FRAMES AND CHASSIS

Fig. 1 - Current Equa-Flex unit with 2 bolts

Fig. 2 - Equa-Flex unit with bolt removed

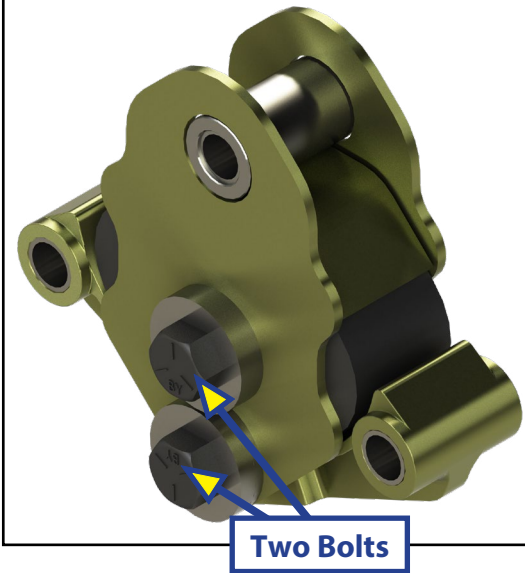
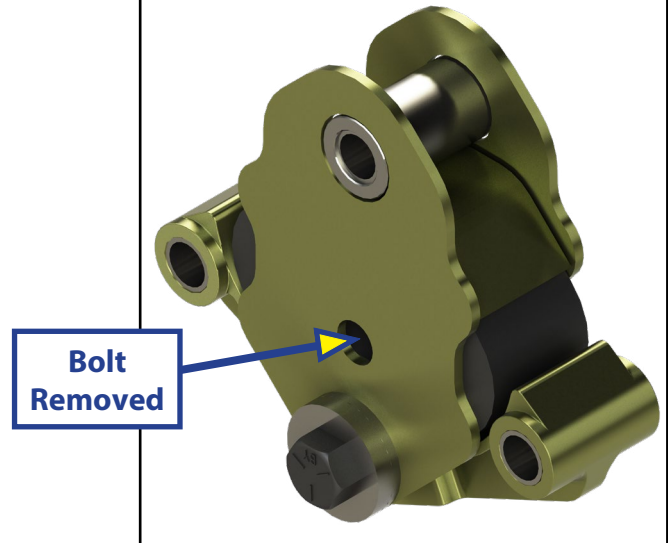
The upper bolt prevents mounting the Equa-Flex suspension unit in the top hole of two-hole frame hangers. To lower the trailer frame height, LCI has tested and concluded the upper bolt can be removed without detriment to the function or durability of the unit. With the trailer supported on jack stands, use a $\frac{13}{16}$ " socket and wrench to remove the upper bolt, nut, and washers. Once removed, the Equa-Flex unit can be reinstalled into the upper hanger hole if desired to lower the frame height of the unit. To decrease the unit further, the shackle links can be changed out and longer ones installed. The longer shackle will decrease frame height an additional $\frac{3}{8}$ ". Order Kit Part #146294 for a tandem axle application. Old shackle links measure 2.25" from hole center to hole center, new ones measure 3.125".
